Circuit Analysis Report

| Test IC | AT86RF212 | |
| Crystal | Holder | NX2520SA |

2. CIRCUIT DIAGRAM

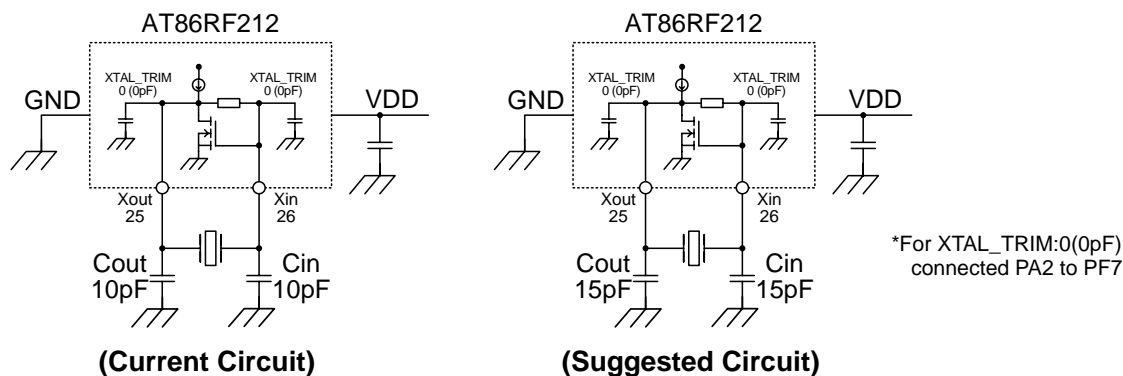
- 1) This crystal unit requires negative resistance of $-R = 900\Omega$ minimum for stable oscillation
- 2) Circuit characteristics

- 3) Although the negative resistance of the current circuit is over our target, it seems too large.
- 4) In order to improve negative resistance, we recommend changing external capacitance values from Cout/Cin=10pF/10F to **Cout/Cin=15pF/15pF**. Besides, we recommend changing crystal load capacitance value from CL=8pF to **CL=10pF** in order to improve frequency deviation.

| Circuit | Cout/Cin | XTAL_TRIM (Internal Cap) | Frequency deviation dF/F | Negative Resistance -R | Drive Level DL | Startup time Tstr |
|-----------|-----------|-----------------------------|---|------------------------------|-------------------|-------------------------|
| Suggested | 15pF/15pF | 0 (0pF) | -4ppm (CL=10pF[IEC]) Ref.: -22ppm (CL=8pF[IEC]) | 1970 Ω | Less than 10uW | 2.5ms |
